Access Compliance Report

Public Rights-of-Way

Intersection ID: 48516	Main Street: GALLERIA CLUB LN	Cross Street: GALLERIA BV	Location: S
ADA ID: 5E7A8699B8E6	Ramp Type: PerpDiag	Initial Pass/Fail: Fail	Overall Compliance: No
Codes/Mitigation Info/Possible Solution		Field Measurements/Component Compliance	
Severity Score: 8.75

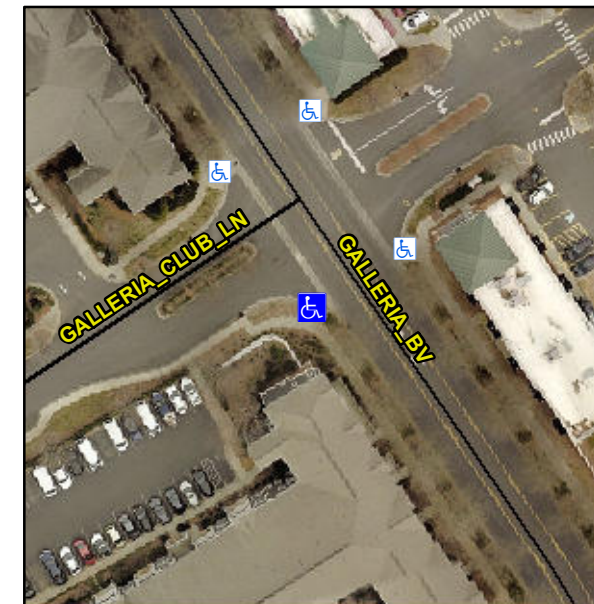
Not Found, R304.5.1

Compliance	Description	Data	Compliance	Description	Data
N/A	Ramp Length (in)	96.0	Yes	Ramp Slope (%)	7.0
No	Ramp Width (in)	39.0	Yes	Ramp XSlope (%)	0.6
N/A	Flare Type LT	N/A	N/A	Flare Type RT	N/A
N/A	Flare Slope LT (%)	N/A	N/A	Flare Slope RT (%)	N/A
N/A	Flare Traversable LT?	N/A	N/A	Flare Traversable RT?	N/A
N/A	Landing Length (in)	N/A	N/A	DWS Provided?	N/A
N/A	Landing Width (in)	N/A	N/A	DWS Contrast?	N/A
N/A	Landing Slope (%)	N/A	N/A	DWS Length (in)	N/A
N/A	Landing X Slope (%)	N/A	N/A	DWS Full Width?	N/A
N/A	Landing Curb? (Y/N)	N/A	N/A	DWS Offset (in)	N/A
N/A	Shared Landing?	N/A			
N/A	Gutter Ponding?	N/A	N/A	Gutter Slope (%)	N/A
N/A	Gutter Lip Ht (in)	N/A	N/A	Gutter X Slope (%)	N/A
N/A	Painted X Walk1?	No	N/A	Painted X Walk2?	No
	X Walk 1 Direction	To NE		X Walk 2 Direction	To NW
N/A	X Walk 1 Width (in)	N/A	N/A	X Walk 2 Width (in)	N/A
	X Walk 1 Slope (%)	3.5		X Walk 2 Slope (%)	1.8
	X Walk 1 X Slope (%)	0.9		X Walk 2 X Slope (%)	1.1

Remove & Replace Curb Ramp With Two New Directional Ramps or Equivalent.
